**CLEPA Proposal for revision to the specifications to the Child restraint system envelopes as specified in TRANS/WP.29/GRSP/2001/15/Rev.2 and the relevant cross references in TRANS/WP.29/GRSP/2001/16/Rev.2**

TRANS/WP.29/GRSP/2001/15/Rev.2

**4. ISOFIX child restraint system size classes and fixtures**  
Insert new class **B1- ISO/F3: Reduced-Height Forward Facing toddler CRS (modified)**

**Figure 2 - ISO/F2 envelope dimensions for a reduced-height forward-facing toddler CRS, (height 650 mm) - ISOFIX SIZE CLASS B**

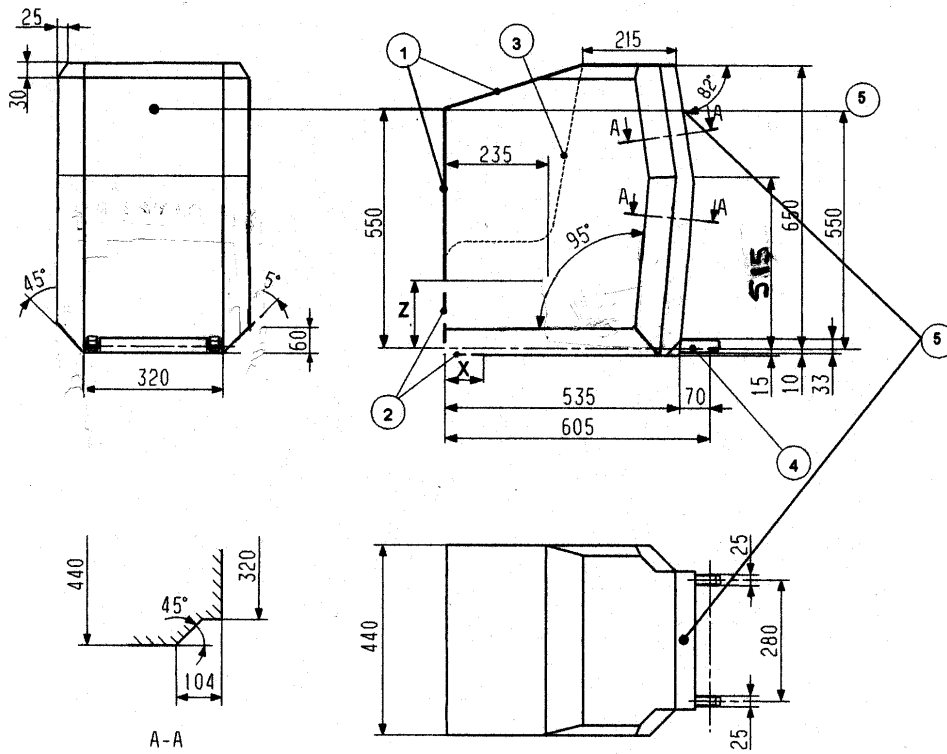
Modify all original drawings 4.1 to 4.5, by removing armrest recess, drawing for fixture B attached is typical.

New 4.3 Reduced height forward-facing toddler child restraint systems envelope

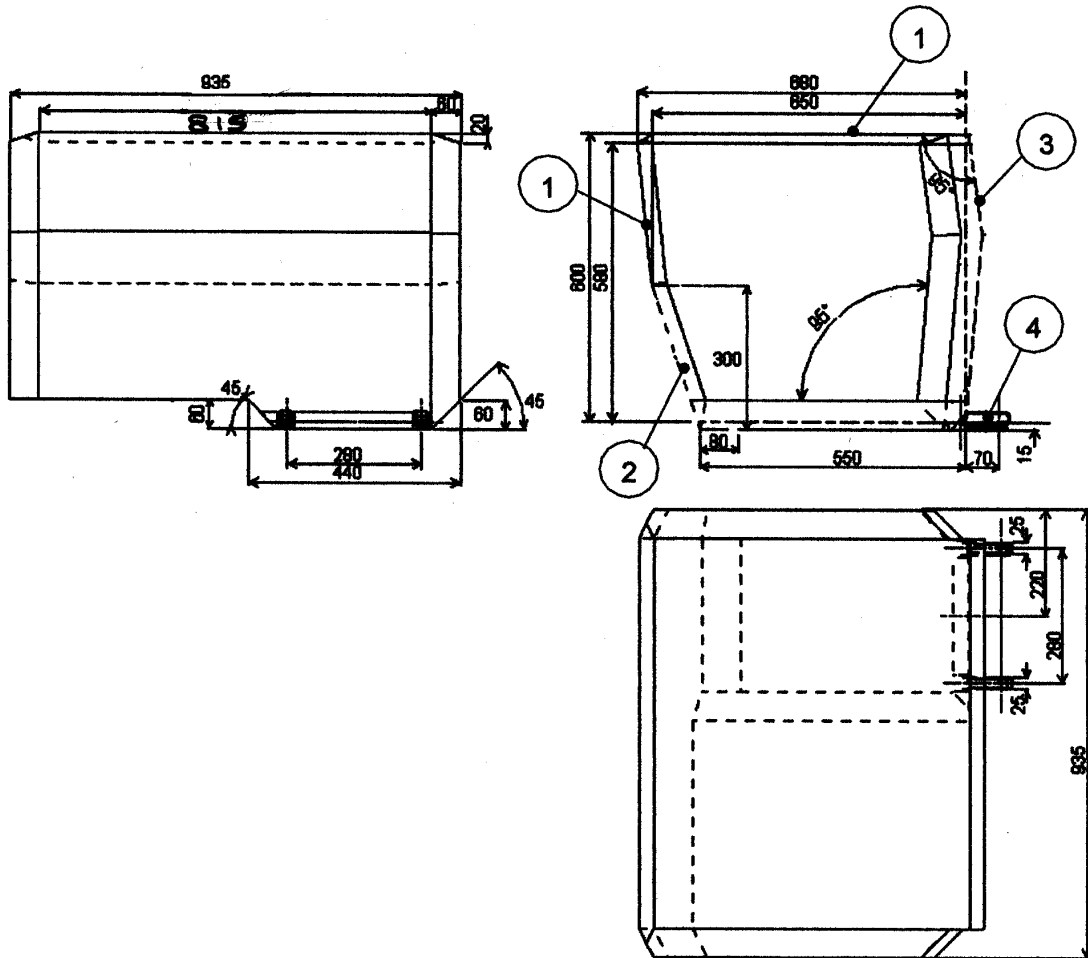
Add new § 4.3 B1- ISO/F3: Reduced-Height Forward Facing toddler CRS (modified) drawing for Class B1, and renumber existing drawings as 4.4, 4.5, 4.6, 4.7.

**Figure 6 — Envelope dimensions for Lateral facing position CRS – ISO/L1 – ISOFIX SIZE CLASS F or symmetrically opposite – ISO/L2 – ISOFIX SIZE CLASS G**

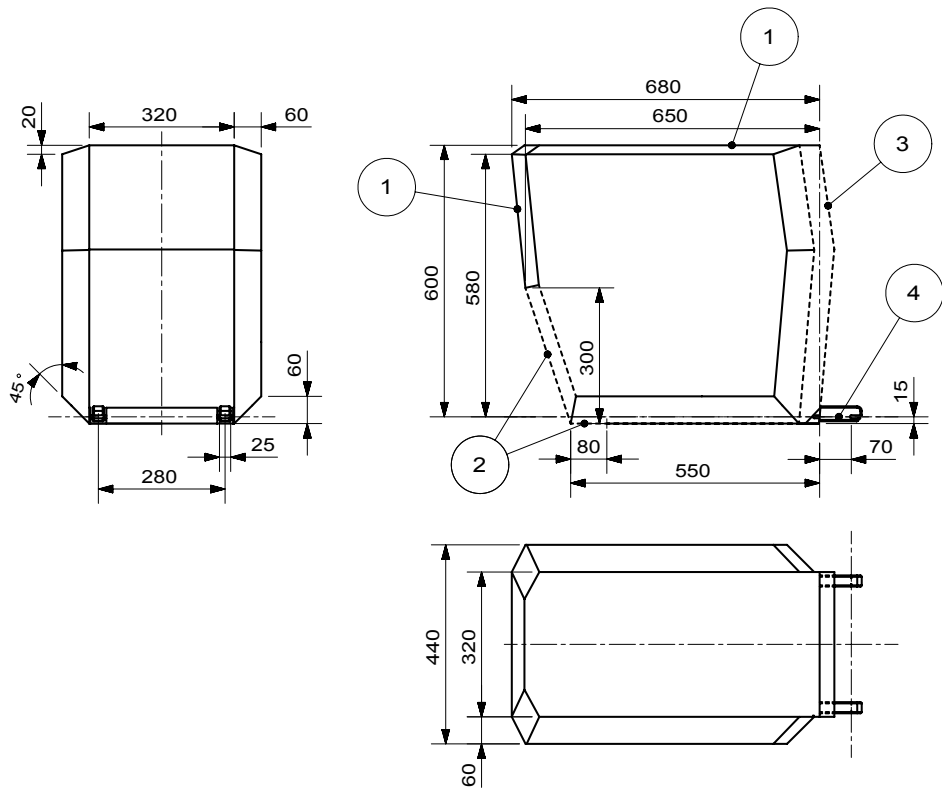
Revise old drawing 4.6 (New 4.7) Lateral facing child restraint systems envelope by correcting dimension 915 to 815 mm.
